INTER-OFFICE MEMORANDUM

SUBJECT: AC-24-22, VA-2024-00229, PR-2022-006844

Carol Johnson appeals the Site Plan-Administrative decision to approve a Site Plan for all or a portion of TRACT A THE PEARL ADDITION (being a replat of Tracts 107-B, 107-C together with Tract 106-A within projected Section 18 T10 N, R3E) zoned MX-M and R1-A, located at 1701/1623 Central Avenue, NW containing approximately 0.5767 acre(s). (J-13)

REQUEST

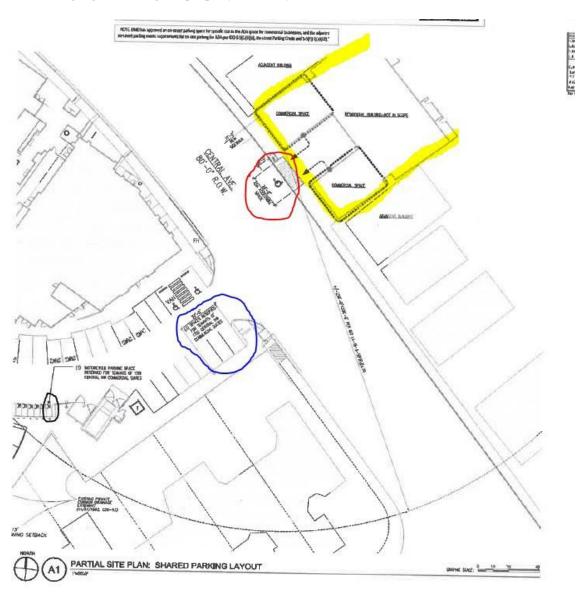
The commercial portion only has access from Central Avenue and is memorialized in a Shared Parking Agreement recorded with the County Clerk (standard practice). The commercial access is in the form of dedicated on-street parking ADA space on Central in front of the project, as approved by the Department of Municipal Development (DMD). Three required spaces and one motorcycle space is across Central Avenue on property owned by the same applicant. This type of parking agreement is allowed per IDO 5-5(C)(5)(b) 'Shared Parking Reduction' and IDO 5-5(C)(6)(e) 'Off-site Parking Credit':

- 1. The provision of required parking at an off-site parking area may be counted toward required off-street parking spaces on a 1-for-1 basis and is allowed for 100 percent of the required parking spaces, except that those required to satisfy the Americans with Disabilities Act shall be provided on the site of the building or use.
- 2. Off-site parking must meet the location standards in Subsection 14-16-5-5(F)(1)(a) and shall be guaranteed by a legally binding agreement between the owner of the parking area and the owner of the building or use that is located on a different lot and served by the parking area.

The location standard for this project is that the designated parking is within 330 feet of the premises served by the parking (See IDO 14-16-5-5(F)(1)(a)(10)). These parking arrangements are in support of Main Street/Premium Transit for this segment of Central which emphasize access by transit and pedestrians. (See "Approved Shared Parking Agreement" in 'Submittals' section of the Record.)

Figure 3. The Pearl, mixed-use development, approved Site Plan.

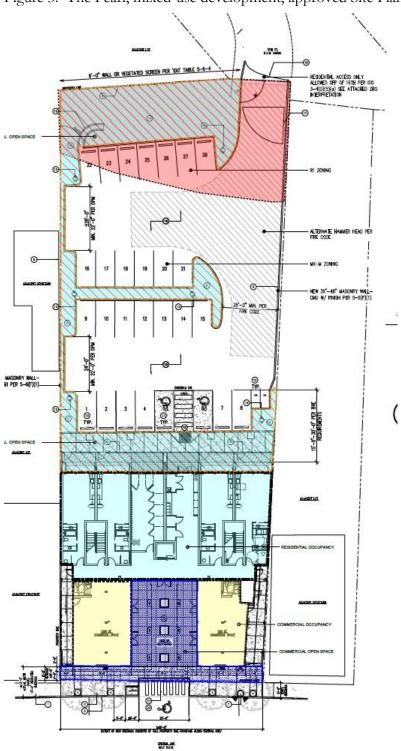
1. **Appellant:** The entrance and exit to the Pearl should be from Central and not from 16th Street, which is a clear violation of Character Protection Overlay Zone 3 in general and in spirit, with particular reference to IDO 14-16-3-4(D)(5)(a)2(b) "For properties west of 14th Street, primary vehicular access shall be from Central Avenue. Access to non-residential development along Central from 15th Street, 16th Street, and Fruit Avenue is prohibited."

In conclusion, the proposed parking area located to the rear (north end) of the subject site with access for a residential use on 16th Street complies with the provisions of IDO 14-16-3-4(D)(5)(a)2.b. To address the concerns of existing adjacent neighbors regarding potential changes to 16th Street as a result of this proposed development, the parking area shall be limited only to residential tenants of the proposed development and should be gated to discourage access by others. It is also strongly recommended that all potential impacts to 16th Street resulting from the proposed development be mitigated without creating major changes to the street's existing character, parking scheme, and usage. (See 'Interpretation-14-16-3-4 'Additional Information' Section of the Record.)

Staff incorporated the ZEO interpretation in its review to approve the multi-family portion of the project to take parking access from 16th Street. The 34 units have 28 parking spaces.

The **residential** portion of the project will generate approximately 17 trips in the AM peak hour and 27 trips in the PM peak hour, based on the latest ITE Trip Generation Manual. All residential required parking is north of the multi-family building with access via 16th Street,

which is permitted by the provisions for Downtown Neighborhood Area – CPO-3 contained in IDO 14-16-3-4(D)(5)(a)2.
